Title - Sujet CCGC -SOLAR AIR HEATING WALL SYSTEM	
Solicitation No. - N° de l'invitation EB144-150329/A	Amendment No. - N° modif. 004
Client Reference No. - N° de référence du client EB144-15-0329	Date 2014-09-15
GETS Reference No. - N° de référence de SEAG PW-\$HAL-409-9297	
File No. - N° de dossier HAL-4-73040 (409)	CCC No./N° CCC - FMS No./N° VME
Solicitation Closes - L'invitation prend fin at - à 02:00 PM on - le 2014-09-23	Time Zone Fuseau horaire Atlantic Daylight Saving Time ADT
F.O.B. - F.A.B. Plant-Usine: <input type="checkbox"/> Destination: <input checked="" type="checkbox"/> Other-Autre: <input type="checkbox"/>	
Address Enquiries to: - Adresser toutes questions à: Taylor, Kathie	Buyer Id - Id de l'acheteur hal409
Telephone No. - N° de téléphone (902) 496-5510 ()	FAX No. - N° de FAX (902) 496-5016
Destination - of Goods, Services, and Construction: Destination - des biens, services et construction:

Solicitation Amendment #04

POINT EDWARD, N.S.
C.C.G. COLLEGE

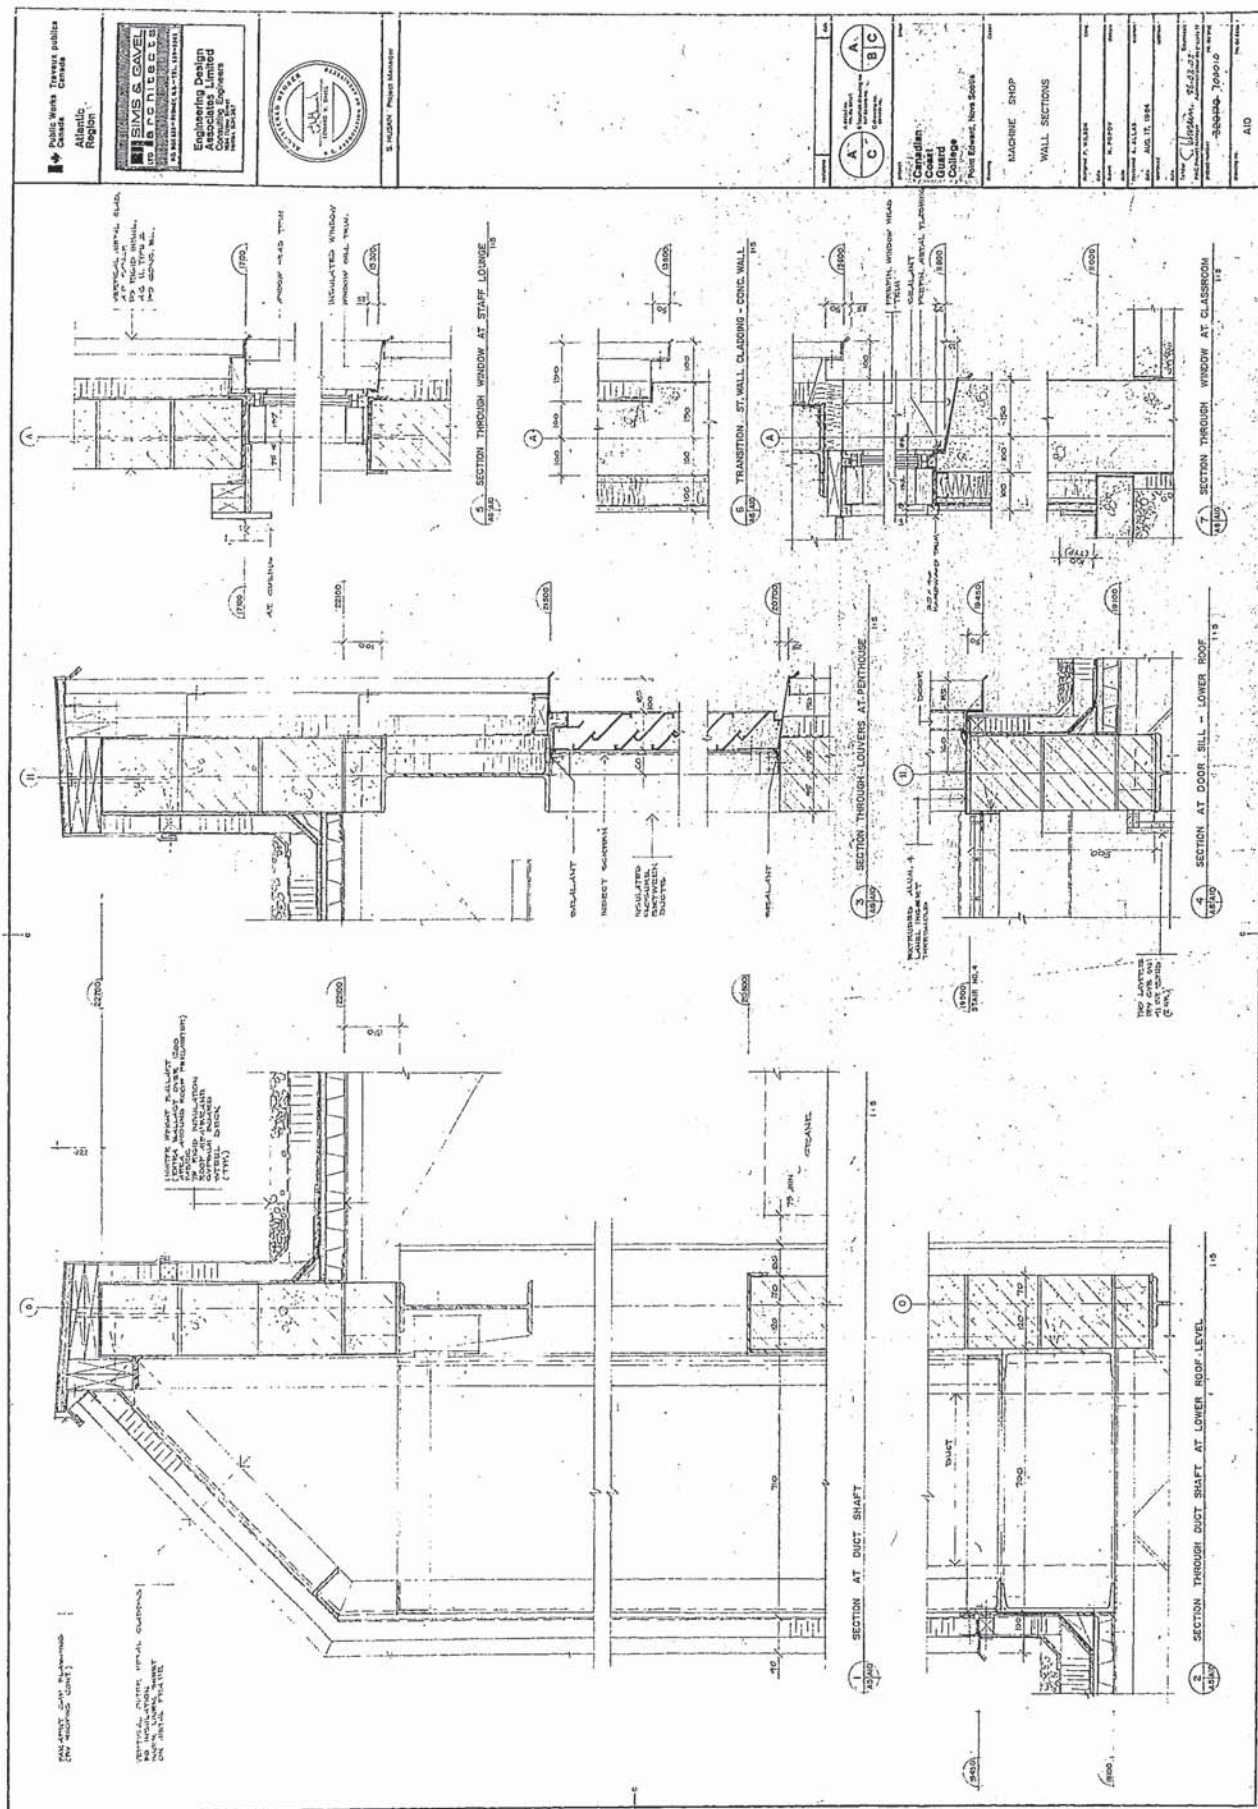
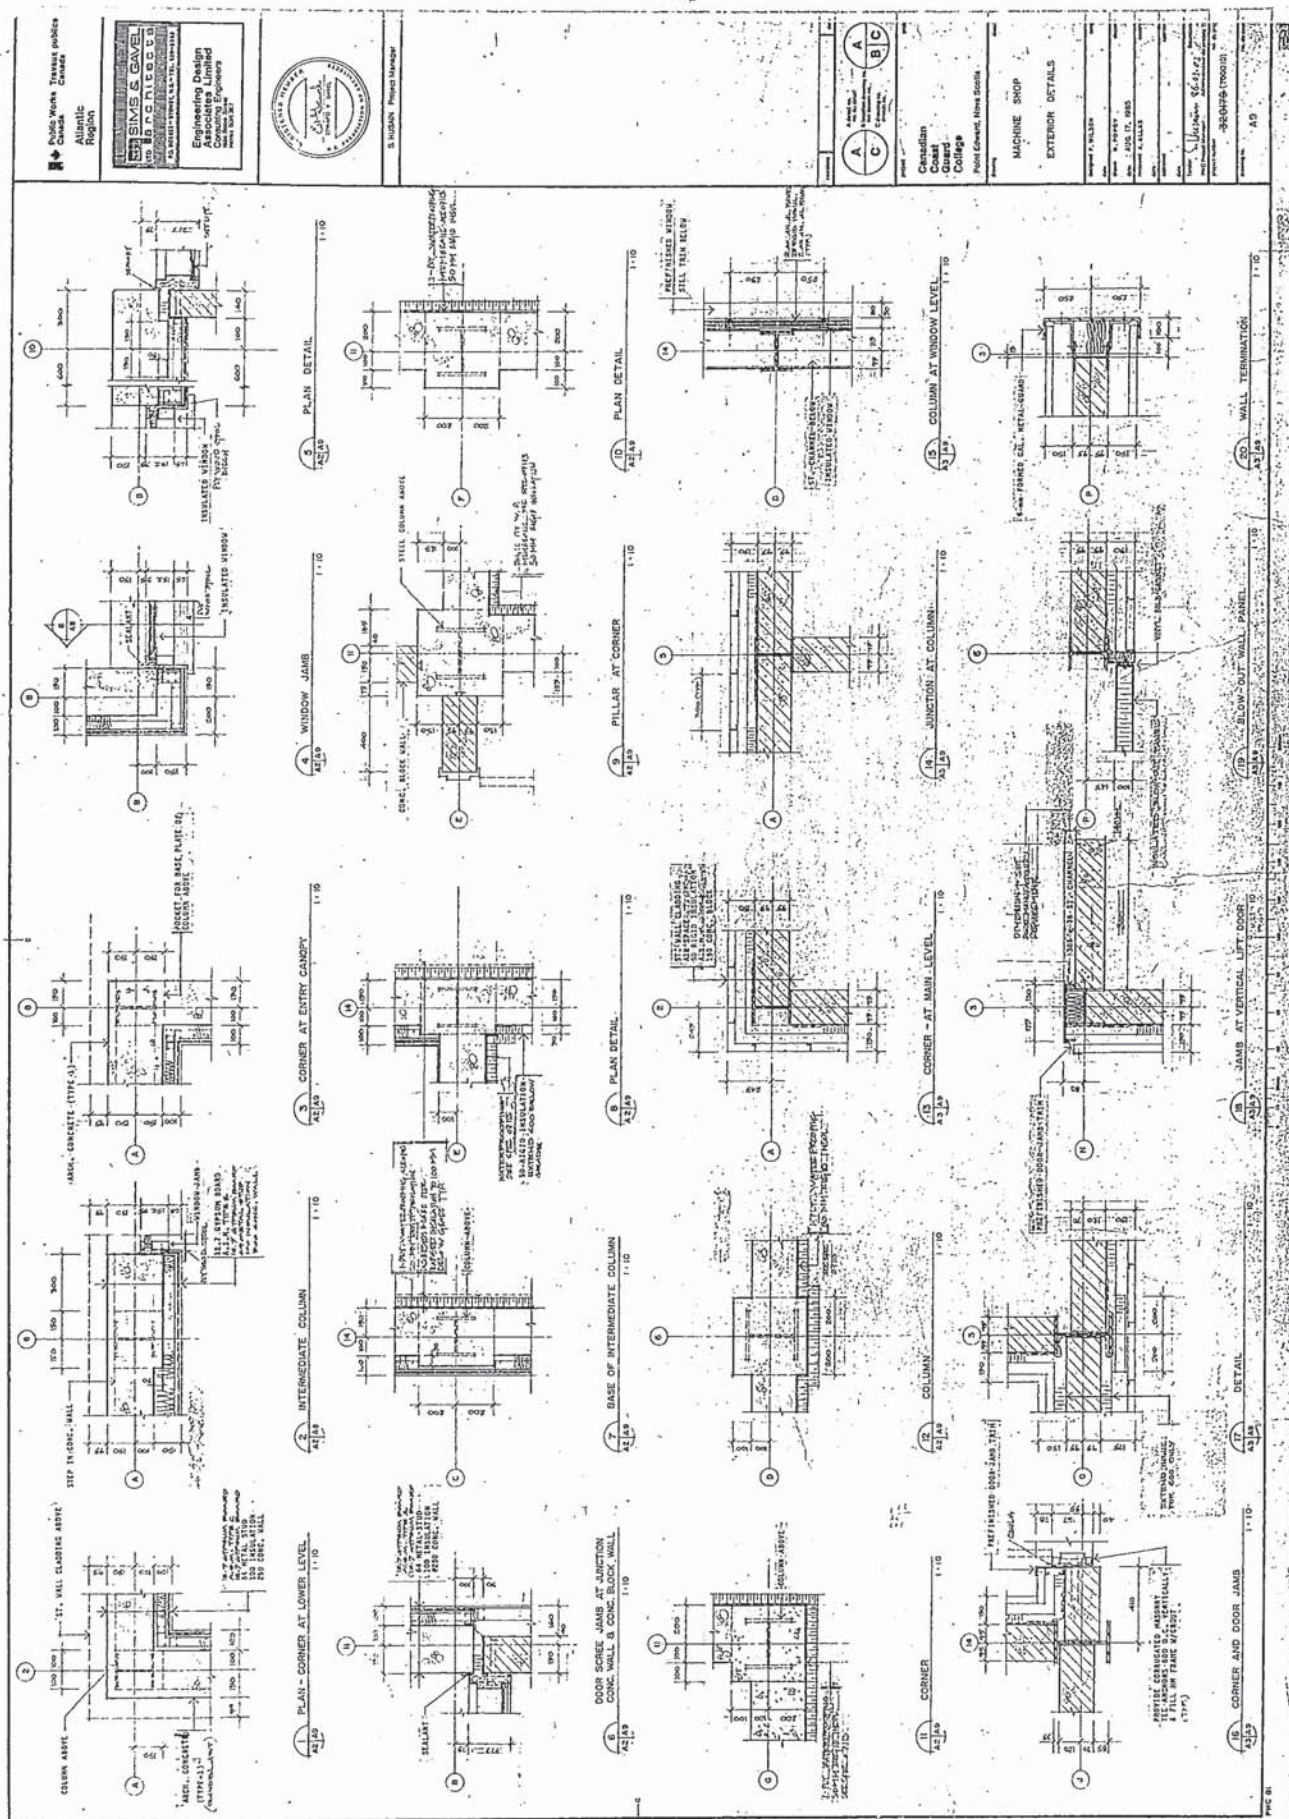
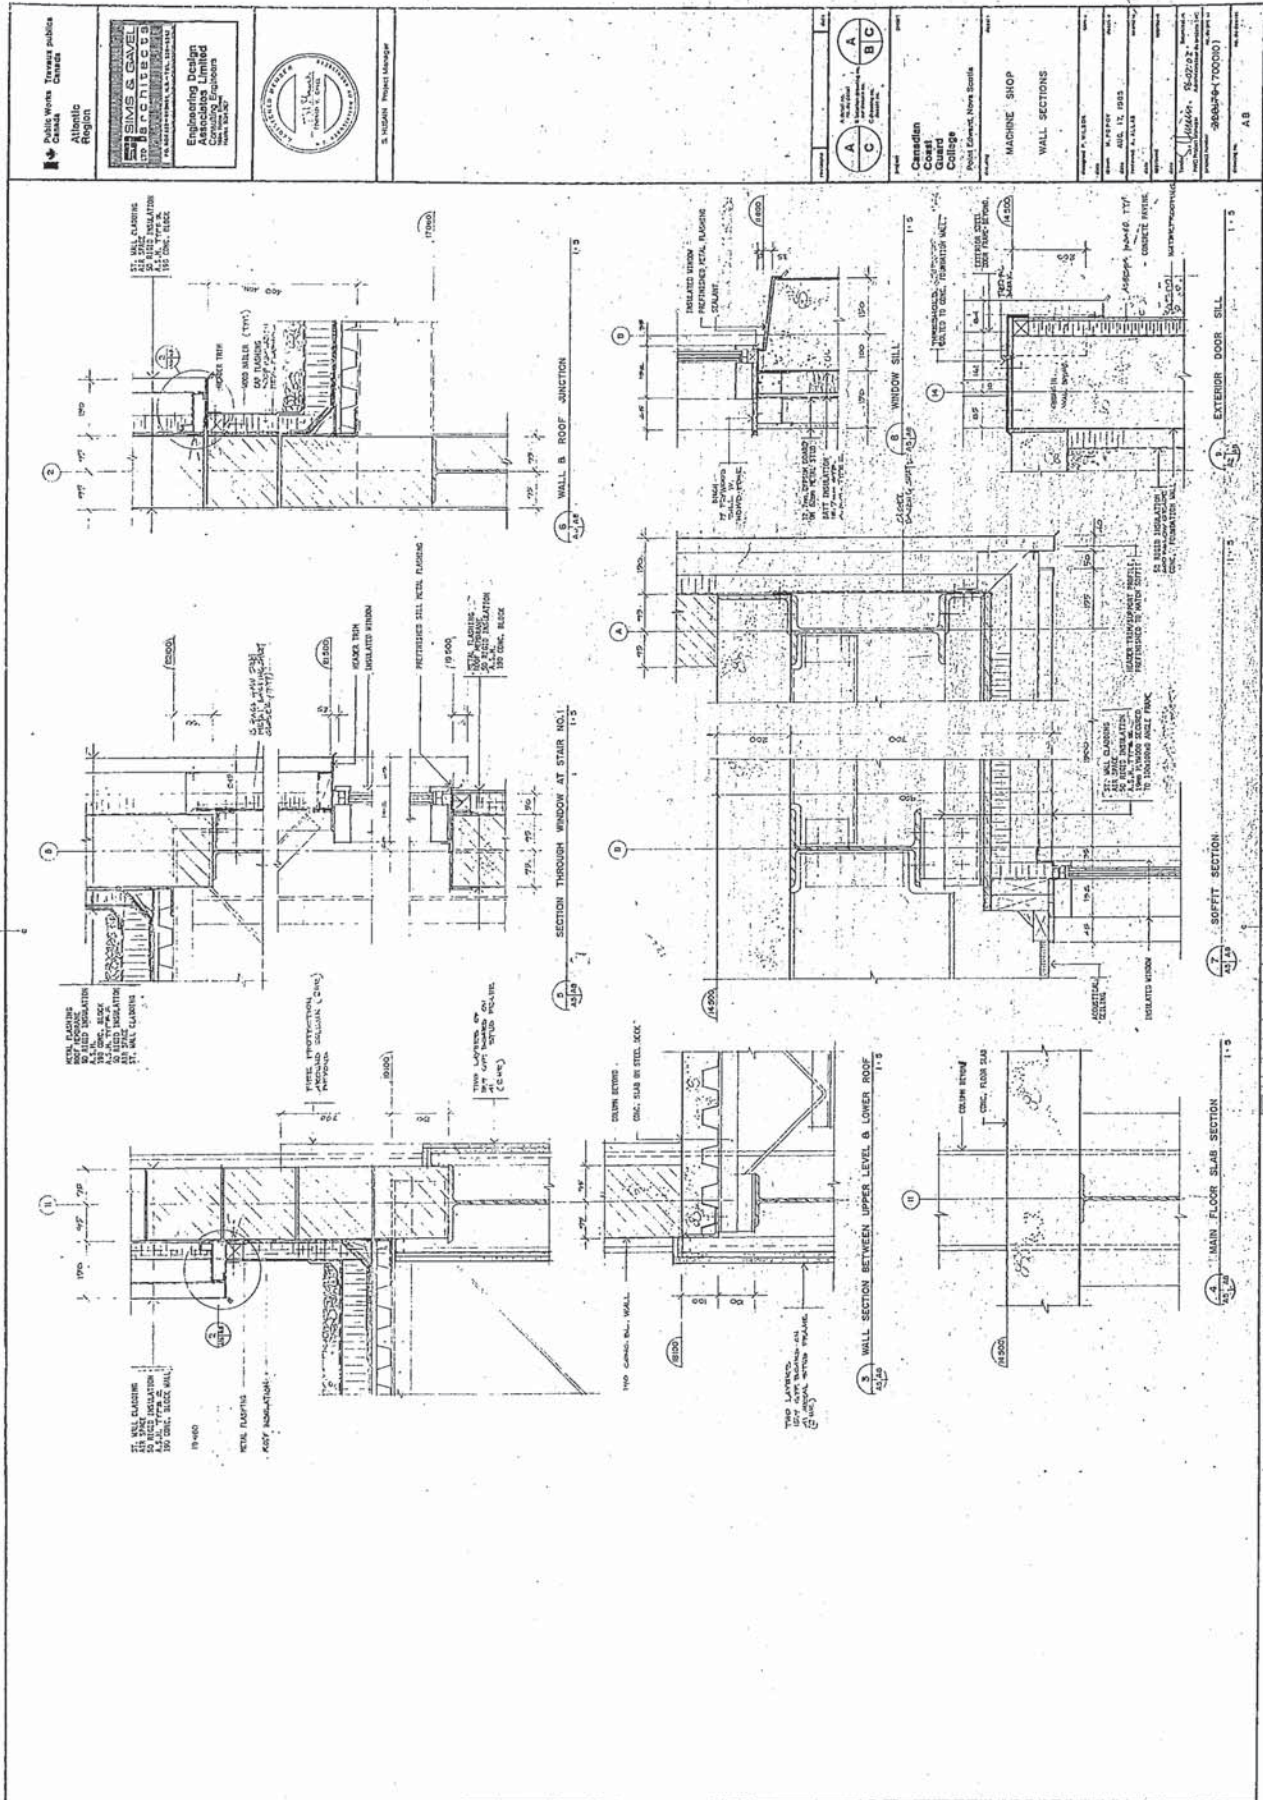
Q12 Do we have any structural drawings of the wall to identify the construction beneath the steel siding that may identify how the steel is fixed to the building ?-Same as question 1 but more specific to what might be required to fasten the system.

A12 See relevant design drawings dated 1984 attached.
